18 December 2019

RE: Submission – Sydney Gateway Road Project (SSI-9737)

Figure 2 - Proposed Intersection Layout - Terminals 2/3 Ingress

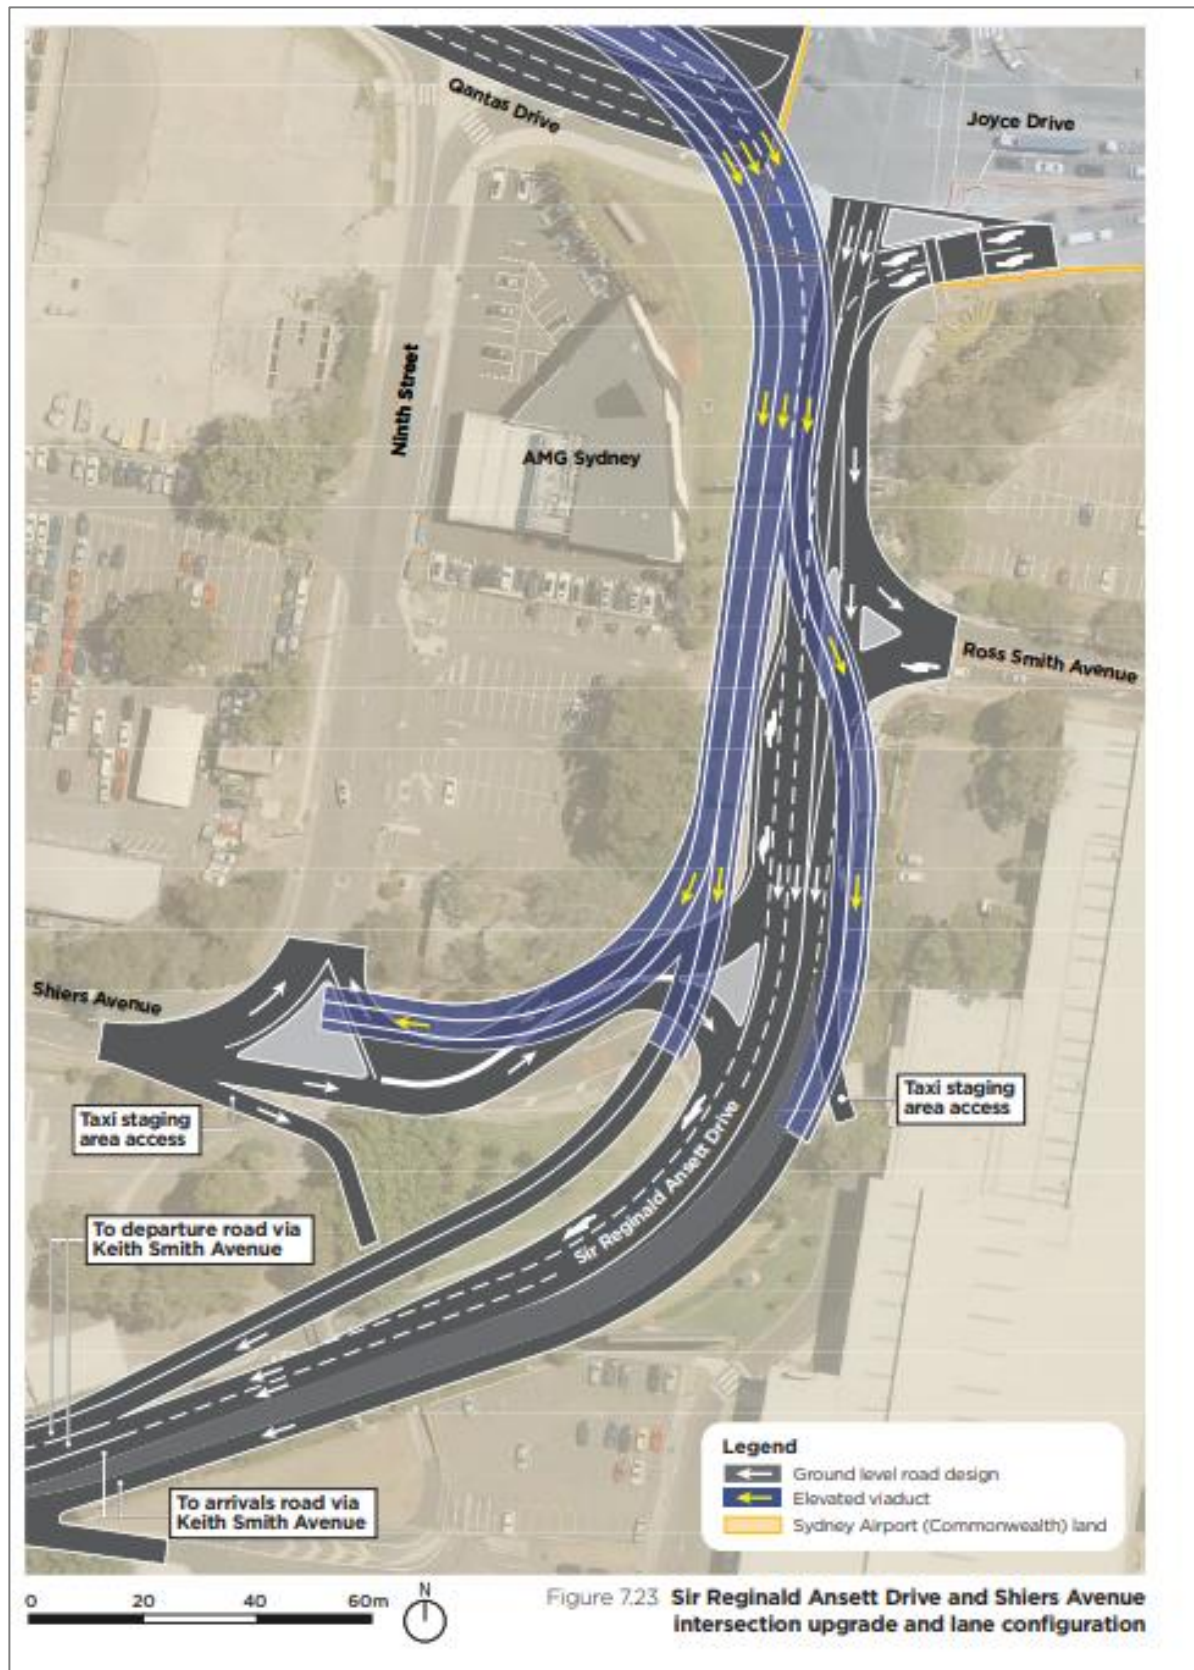
The proposal has not acknowledged that currently all traffic entering the Terminals 2/3 access point passes the intersection of Sir Reginald Ansett Drive and Ross Smith Avenue. The current arrangement facilitates access to the KFC for the passing trade arriving to the terminal. Motorists leaving the airport can also access the KFC by traveling east on Qantas Drive, and utilising the right hand turn into Sir Reginald Ansett Drive.

- + The proposed elevated overpass connecting Terminals 2/3 with the upgraded Qantas Drive terminates after the intersection of Sir Reginald Ansett Drive and Ross Smith Avenue. Consequently, a significant catchment of passing trade will not be in a position to access the businesses along Ross Smith Avenue in a convenient fashion.

- + The ability for east bound traffic on Qantas Drive to turn right into Sir Reginald Ansett Drive is unclear. Should traffic movement be restricted in this regard, it further restricts the ability for passing trade, including east bound motorists leaving Terminals 2/3 from being able to access the KFC via Sir Reginald Ansett Drive and Ross Smith Avenue.

- + The existing right hand turn from Qantas Drive into Sir Reginald Ansett Drive be maintained. The congestion currently experienced at this intersection will be alleviated by the creation of the overpass. It is considered that this right hand turn can be maintained in the amended traffic environment.
